Subject: Product Change Notice

Product: 18V – 15V, 62F – 58F Modules

Affected product numbers: SM0062-018-P, SM0058-016-P, SM0062-017-NB, SM0058-015-NB

Prior mounting hole location dimensions

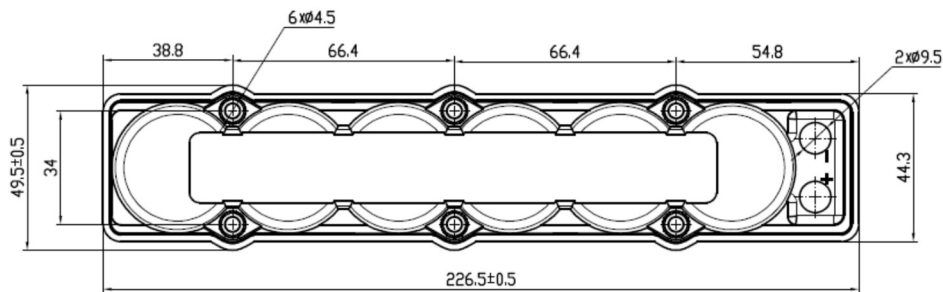
This letter is to notify you of a change to the mounting hole locations and external dimensions of LICAP's module products listed above. This change affects the form and fit of the modules. Modules shipped after May 1, 2022 will have the new mounting hole locations and dimensions. There will be no change to the product number or naming. Please contact your sales representative with any questions.

New mounting hole location dimensions
